Letter of Map Revision for Phase II River Restoration Roaring Fork River Town of Basalt, Eagle County, Colorado

November 25, 2019

IN REPLY REFER TO:
Case No.: 20-08-0275P
Community: Town of Basalt, Eagle County,
and Pitkin County, CO
Community No.: 080052, 080051, 080287

**LETTER OF MAP REVISION
 EXHIBIT 1 - WORKMAP**

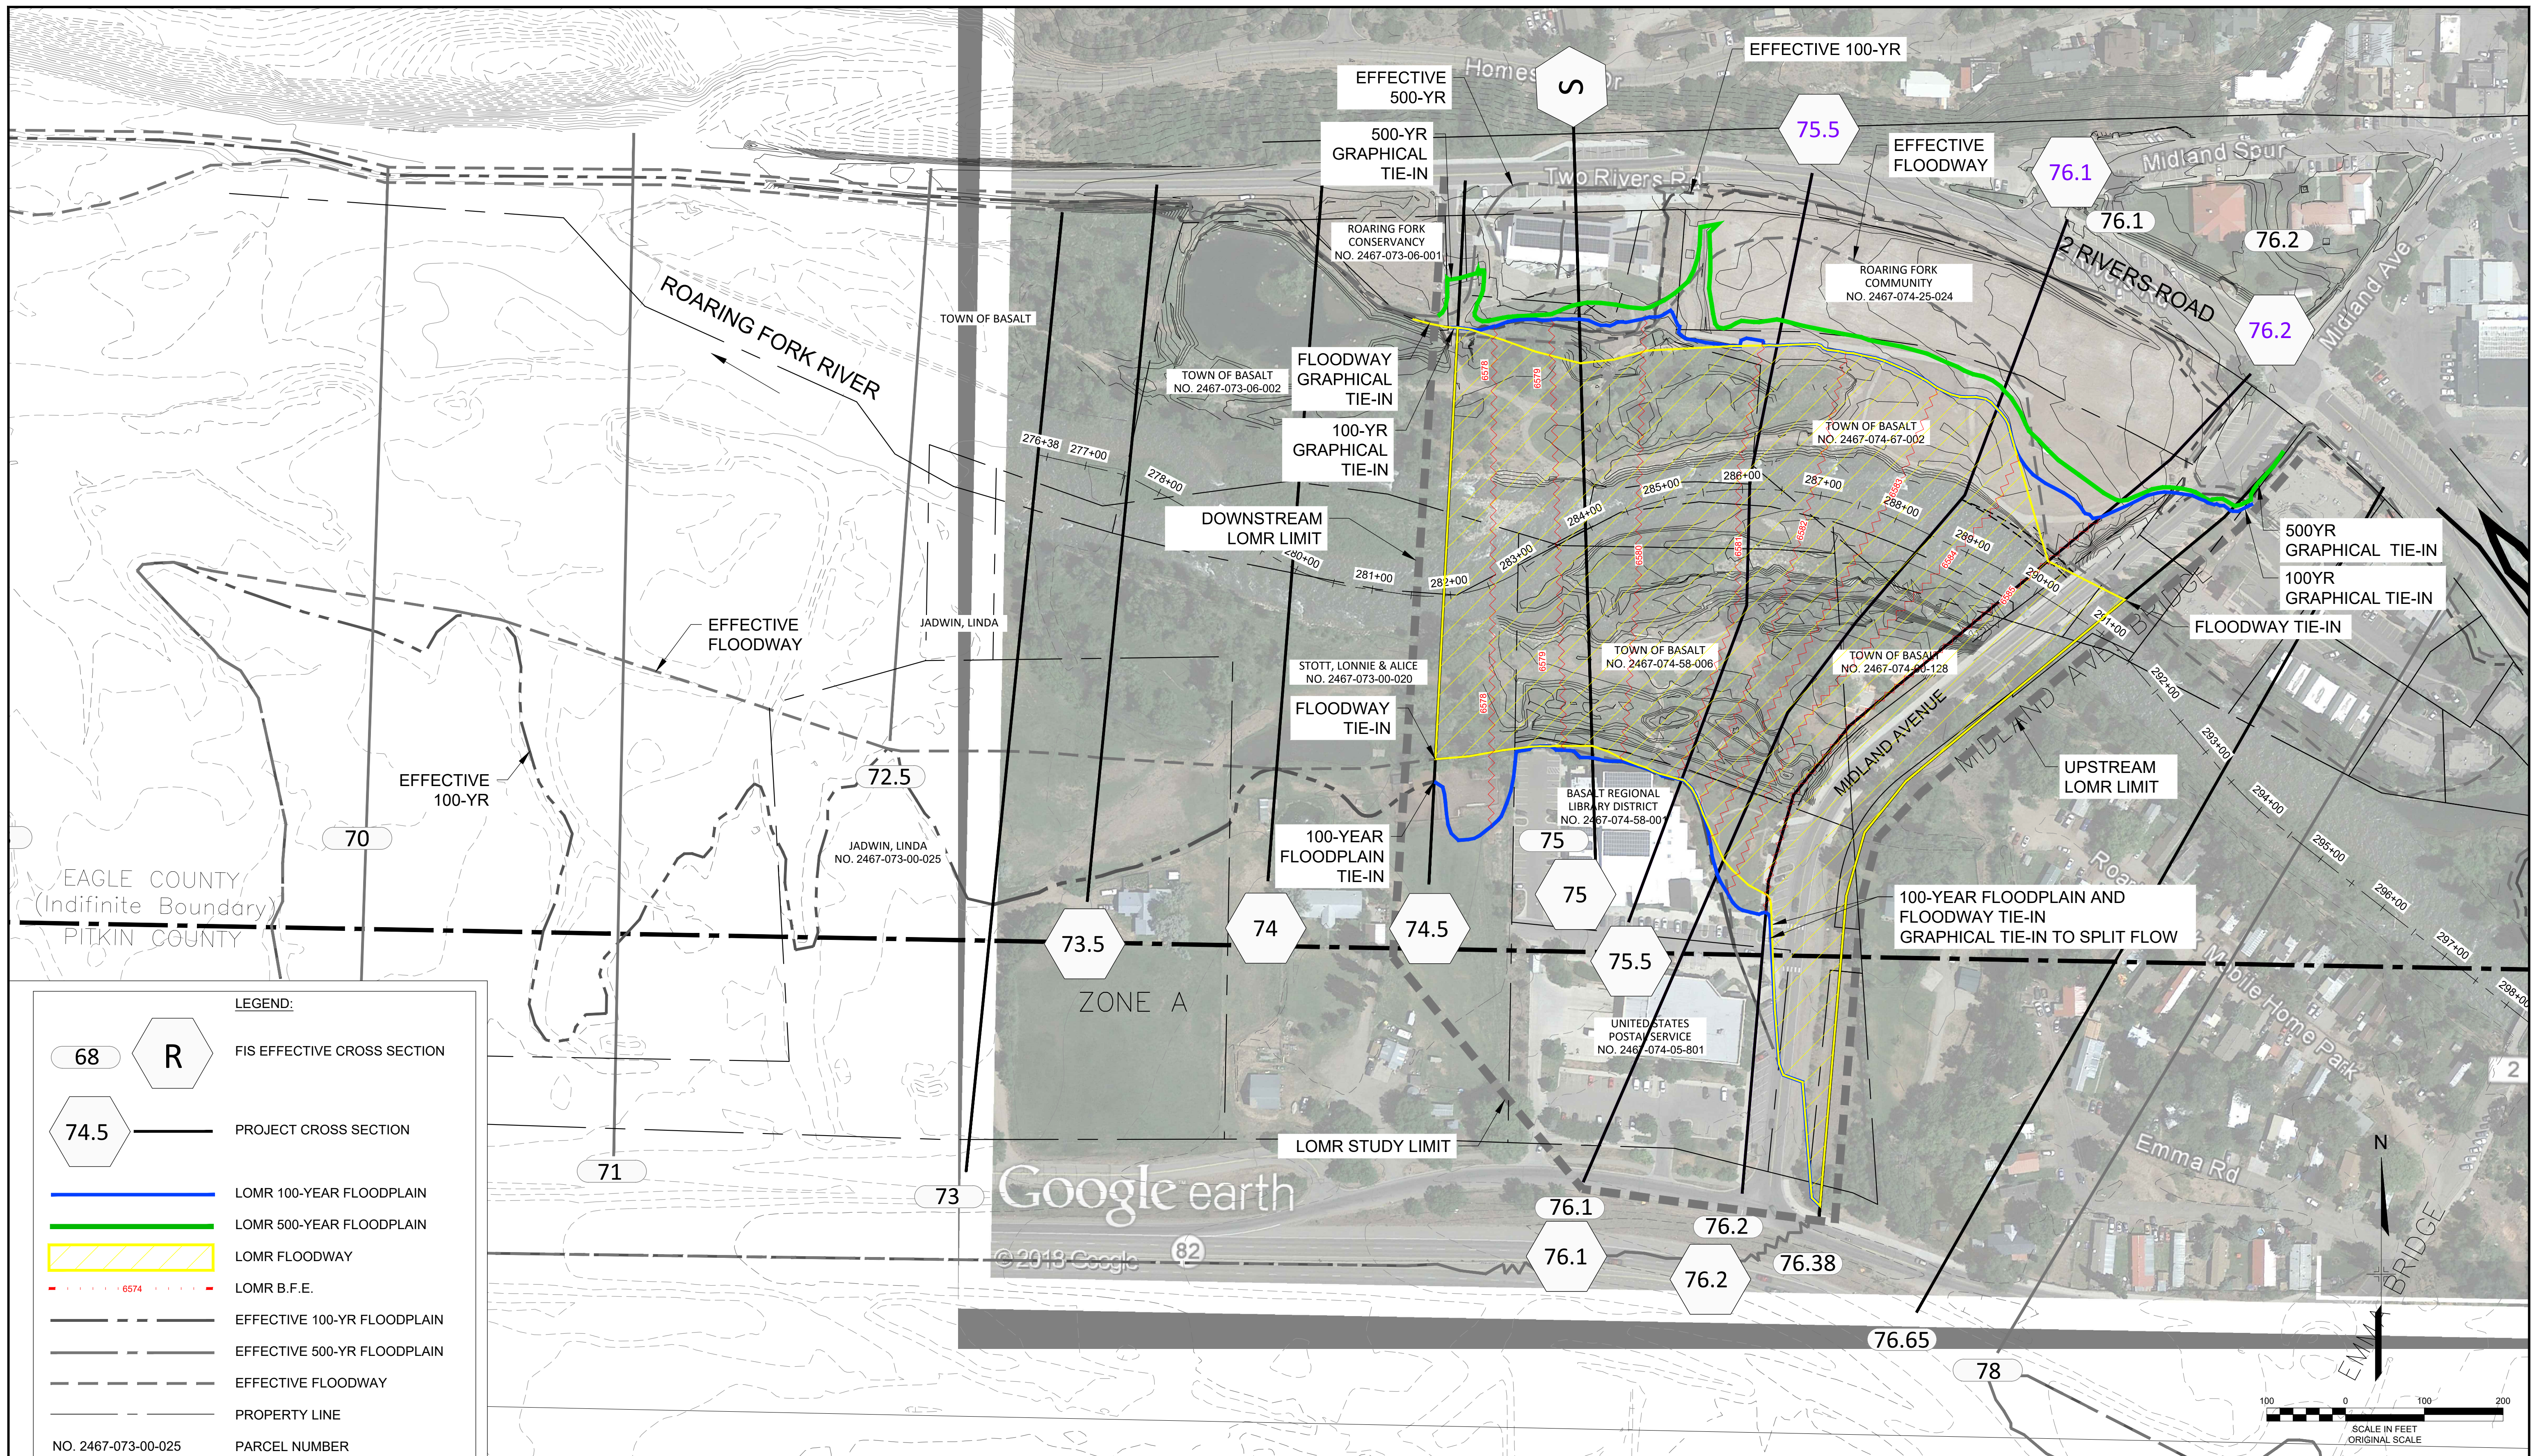
2. The submitted topographic work map, entitled "Roaring Fork River Restoration at Basalt River Park – Phase II," prepared by Matrix Design Group, dated December 23, 2019, does not provide essential information required to complete our review of this request. Please submit a revised topographic work map, certified by a registered Professional Engineer, that shows all applicable items listed in Section C of Application/Certification Form 2, entitled "Riverine Hydrology and Hydraulics Form," including the following information:

- a. Please show the flow line used in the hydraulic model.
 - b. For clarity, please revise the format (line type, color, scale) of the effective 0.2-percent-annual-chance floodplain, base floodplain, and regulatory floodway to make them more visible.

- c. Please label the topographic contours so that the revised floodplain delineations can be verified.

- d. The effective 0.2-percent-annual-chance floodplain, base floodplain, and regulatory floodway boundary delineations were not shown on the above-referenced topographic work map on the south bank upstream of the revision area. Please update the topographic work map and show the effective and proposed floodway boundary delineations clearly in different line type and color.

- e. For clarity and ease of viewing, please remove the red base flood elevation (BFE) lines from the work map.
 - f. The base floodplain and regulatory floodway topwidths in the proposed conditions hydraulic analysis do not match the approximate base floodplain and floodway topwidths shown on the above referenced work map at Cross Section 76.38. Please revise to ensure the modeled and mapped topwidths are consistent.

**Town of Basalt
080052**

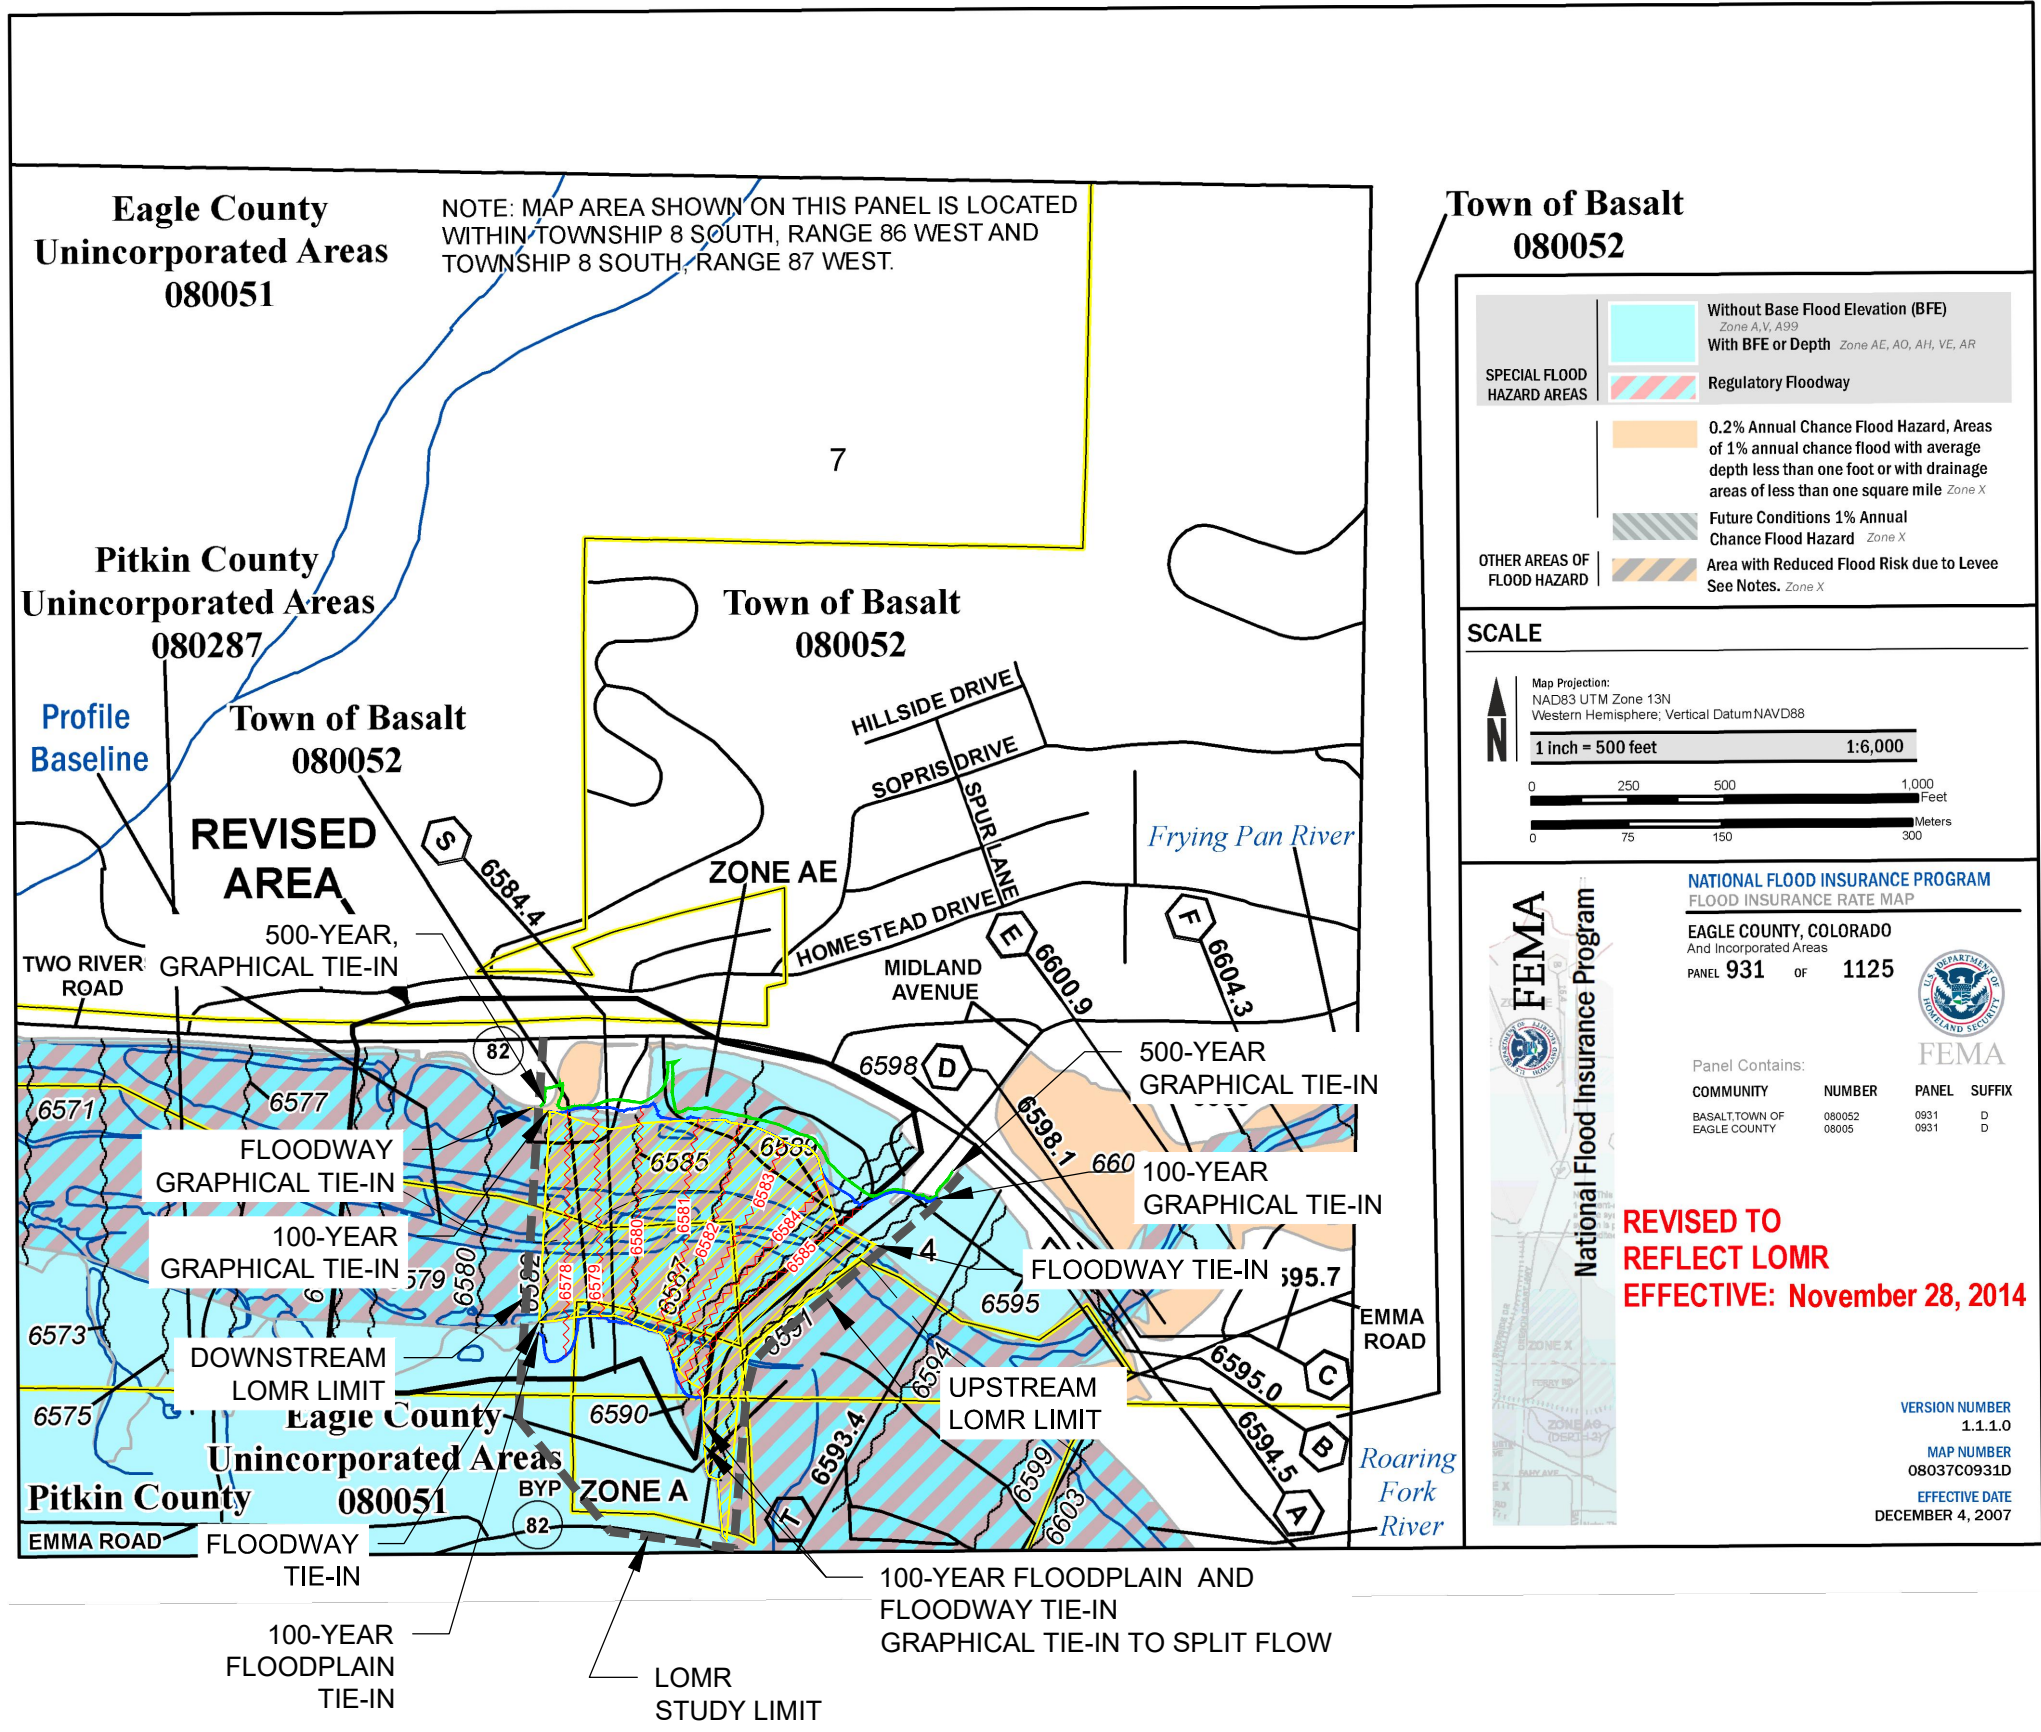
3. The submitted annotated FIRM does not include all the effective FIRM panels affected by your revision request. Our review revealed panel 08097C0081E of the FIRM for Pitkin County, Colorado and Incorporated Areas is affected. Please submit annotated copies of all affected FIRM panels, at the scales of the effective FIRM, that clearly show the revised boundary delineations of the base floodplain shown on the above-referenced topographic work map and how they tie-in to the boundary delineations shown on the effective FIRM at the downstream and upstream ends of the revised reach.

4. Please submit an updated annotated FIRM that is consistent with the changes requested in the items above.
 5. We have received the draft notification that was included in your submission. Once we are confident that there will be no further changes to the modeling and/or mapping, we will provide our comments on the draft so that it can be finalized and distributed.
